## The Progress Power (Gas Fired Power Station) Order

# APPLICATION TO MAKE A NON MATERIAL CHANGE TO THE PROGRESS POWER (GAS FIRED GENERATING STATION) ORDER

**PINS Reference Number:** EN010060  
**Document Reference:** NMC  
**Regulation Number:** Regulation 4  
**Author:** Progress Power Limited

Title:  
 GAS TURBINE GENERATOR OVERLAY Reg5(2)(o)

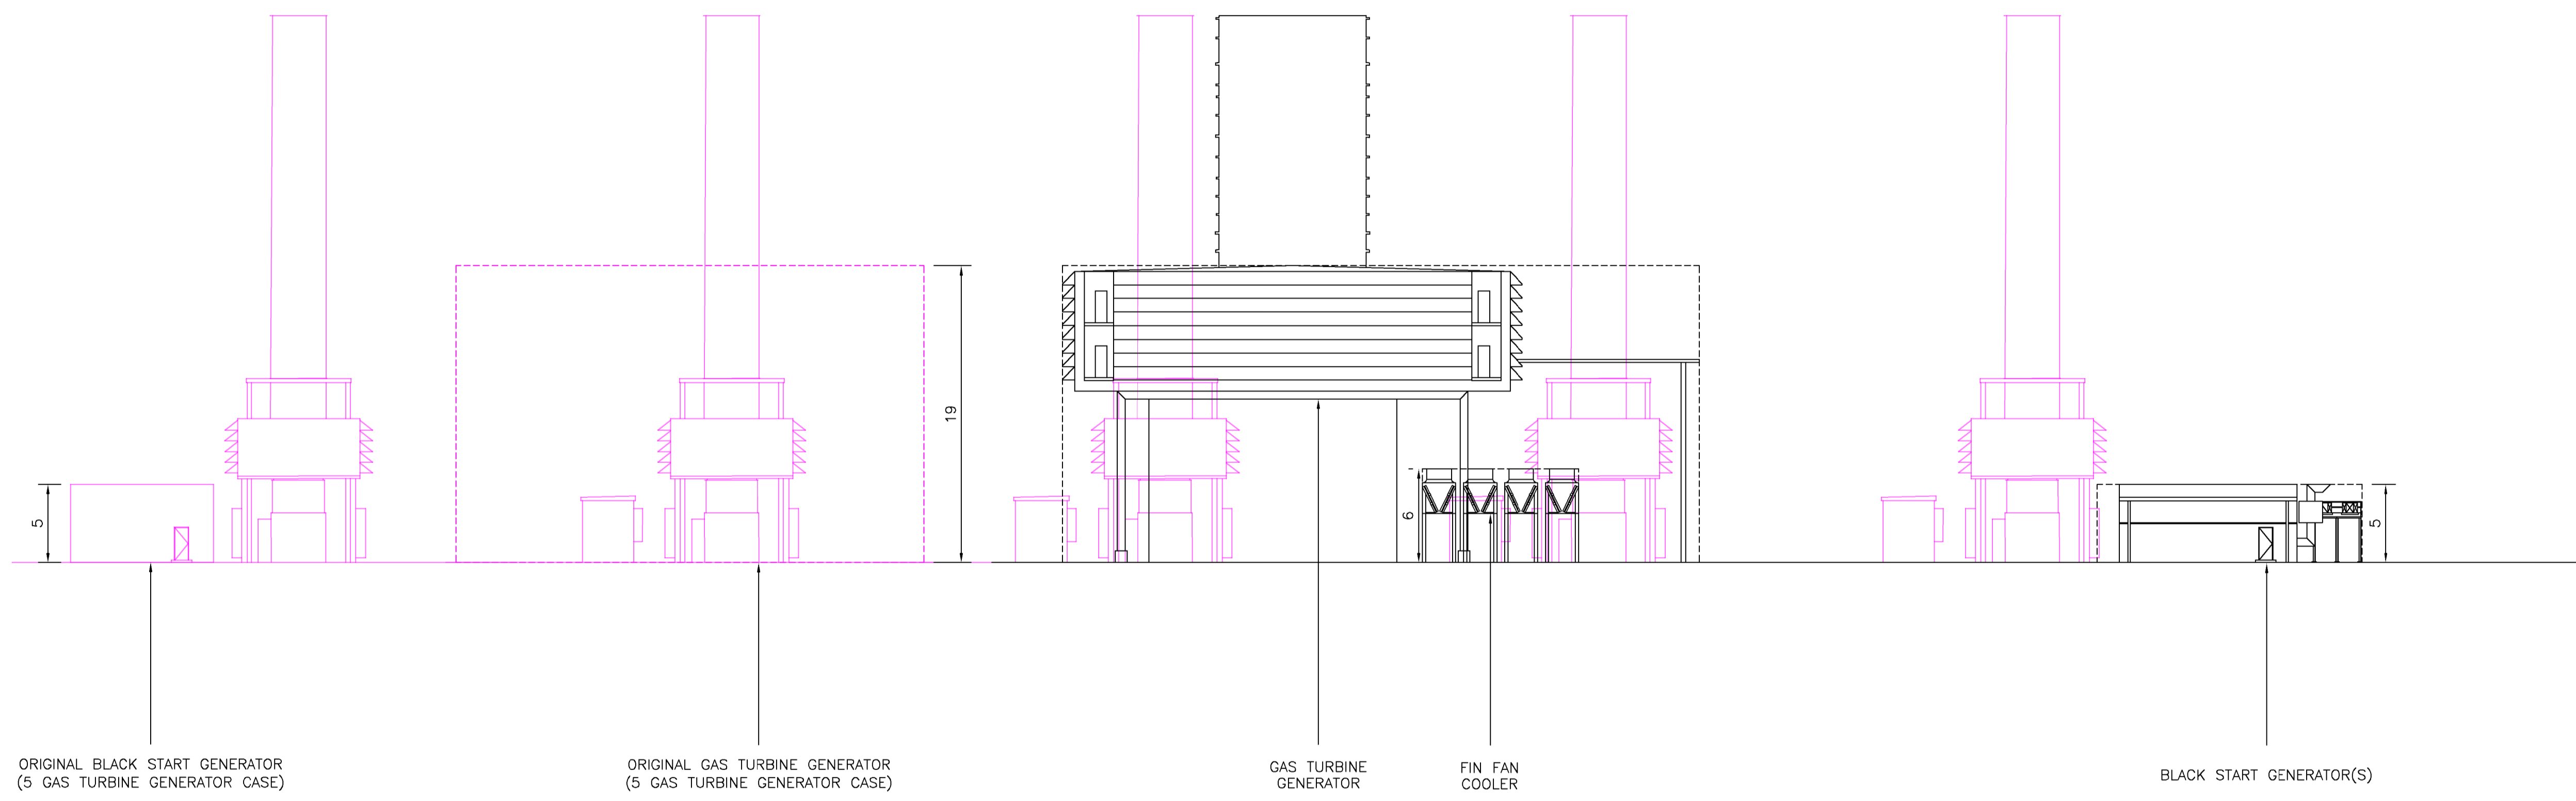
4.2.3 In summary, for **the one GTG solution only**, there is a need to increase the length of the GTG from a maximum of 30 metres to 50 metres to accommodate the diffuser system elements of the GTG and the width from a maximum of 30 metres to 40 metres to accommodate the lube oil system. This would involve a change to Table 2 in Requirement 3, Schedule 2 of the Order. However, there would be no change in the overall footprint of the Power Generation Plant as

Title: **GAS TURBINE GENERATOR, BLACK START GENERATOR AND FIN FAN COOLER ELEVATIONS Reg5(2)(o)**

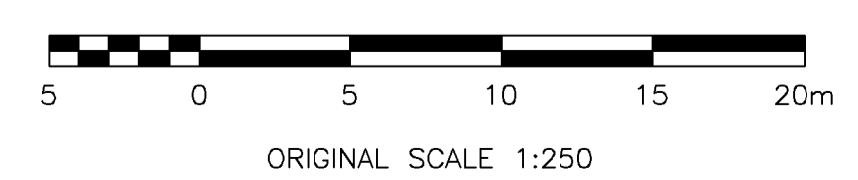
4.6.5 This would involve an amendment to Schedule 1 of the Order and a change to Table 2 in Requirement 3, Schedule 2 of the Order for the single GTG scenario.

Figures 1, 2, 4, 5 and 6 of the Environmental Report show the proposed single GTG scenario and the proposed changes. The screening exercise set out in Chapter 4 of the Environmental Report identifies the potential for a change in the environmental effects predicted in the ES for landscape and visual effects and air quality. The updated assessment for air quality (Chapter 6 of the Environmental Report) has concluded that overall, the Project, with proposed changes, will continue to have a negligible likely impact on air quality in relation to both human and ecological receptors during construction, operation and decommissioning. This applies both for the Project alone and in combination with other proposed facilities in the vicinity of the Project site.

Change Number	Building or Structure	Summary of what is currently authorised under the Order	Suggested Change
		Numbered work 1D authorises development comprising...(i) other ancillary development	<p>as to permit the following parameters for a single GTG scenario:</p> <p>Maximum height: 6 metres</p> <p>Maximum length: 13 metres</p> <p>Maximum width: 10 metres</p>
